APPLICABILITY: 2012-2016MY Impreza 5-door

2013-2016MY XV Crosstrek

SUBJECT: Tonneau Cover Design Change

NUMBER: 15-201-16

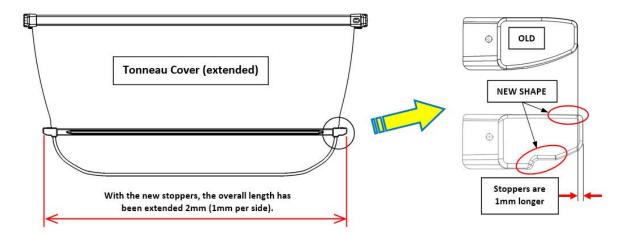
This Service Information bulletin announces a design change to the retractable portion of the tonneau cover made to address customer concerns of the cover retracting on its own while driving on rough roads. The shape and length (an additional 1mm) of the stoppers on both ends of the brace which secure the cover when in use have been changed as shown in the illustration below.

The new tonneau cover was incorporated into FHI production during mid-April 2016. There has also been a running change made during port processing. Use the illustration above to identify the new part by the change in stopper shape.

Description	Part Number
TONNEAU COVER ASSEMBLY	65550FJ020VH
